COUNTY OF LAKE
Department of Public Works
255 North Forbes Street
Lakeport, CA 95453

CHANGE ORDER NO: 2

DATE: 7/10/2017

PROJECT: Dry Creek Road at Dry Creek Bridge Replacement
Federal Project No. BRLO-5914(080)

Description Section G-G

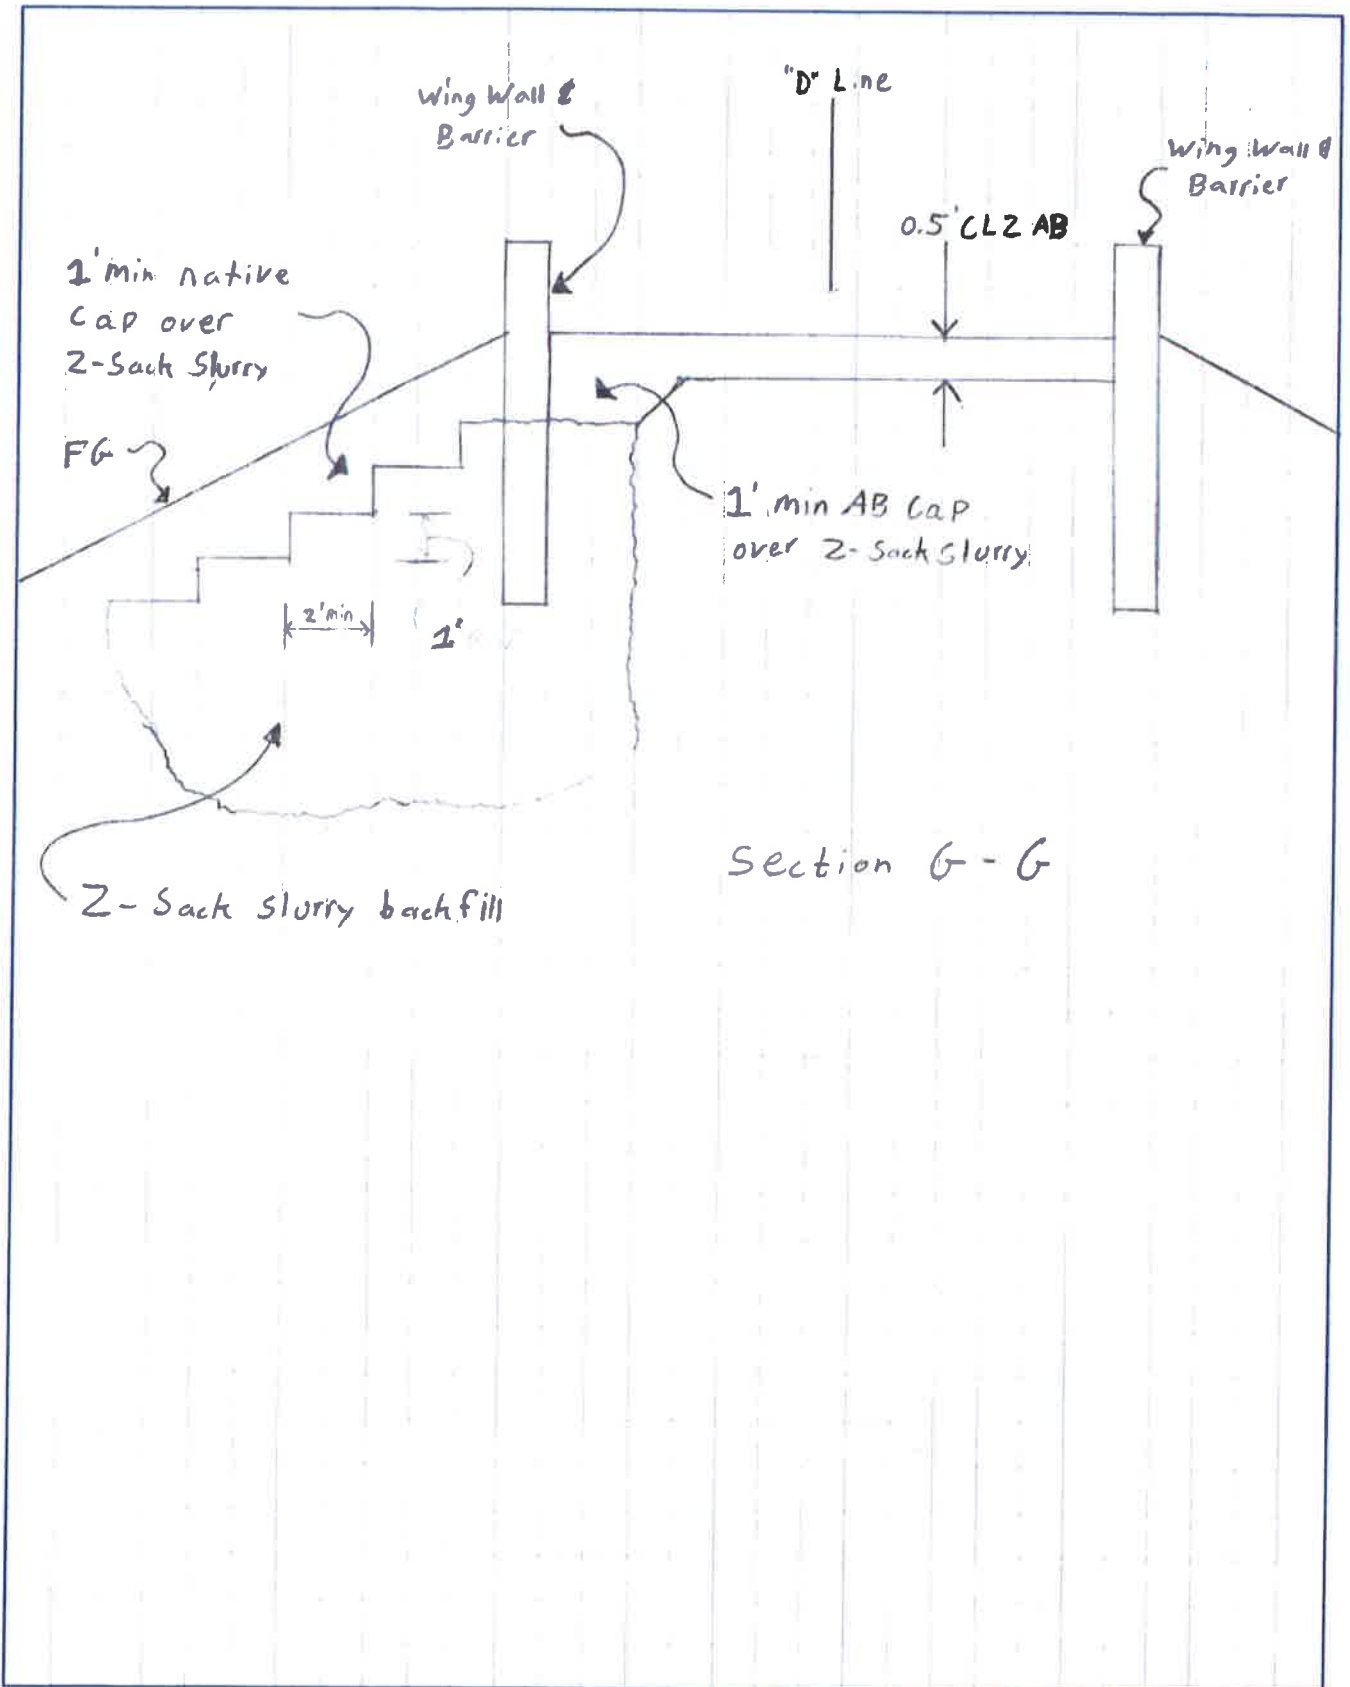
3	<p><u>Extra Work at Force Account</u></p> <p>Perform Emergency Storm Damage Repair Work as shown on revised plan sheets (attached)</p> <p>Adjustment of Contract Time:</p> <p>No adjustment of contract time will be made.</p>	0	\$17,107.01
		64	\$2,637.36

Item No. 3. Over the winter of 2016 and into January of 2017, multiple severe storms overwhelmed drainage systems adjacent to the project, causing erosion and damage to the project site. A repair plan (attached) was developed by QEI to bring the site back to designed condition as well as to restore the adjacent v-ditch to original form. This work required a NEPA revalidation (attached). Work was performed with a Field Order not to exceed of \$30,000.00 (attached).

Description Ditch Volume

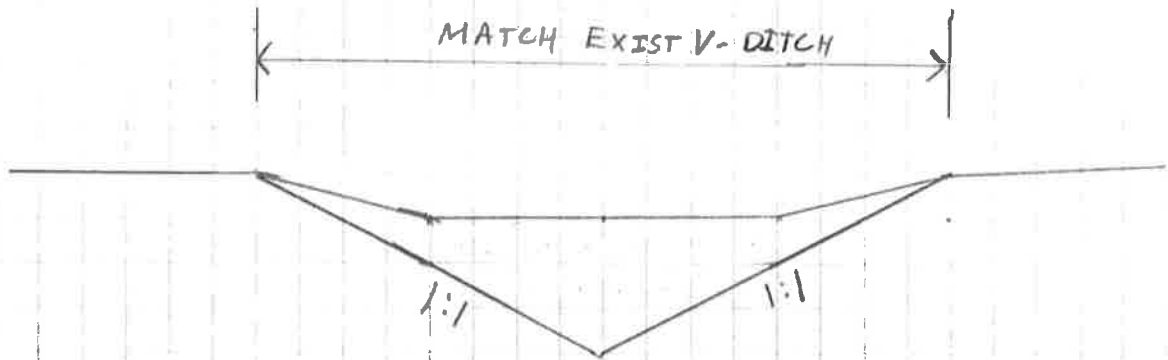
Excavation Area : $(0.125 \text{ ft}^2/\text{box} \times 19 \text{ boxes}) = 2.375 \text{ ft}^2$

Excavation Volume : Length = station 10+00 to 12+00 "D" line
 $= (200 \text{ LF} \times 2.375 \text{ ft}^2) / 27 \text{ ft}^3/\text{yd}^3$
 $= 13.19 \text{ yd}^3$

Say 18 yd³

Note: Material to be used at Repair located at 12+15 Lt "D" Line.
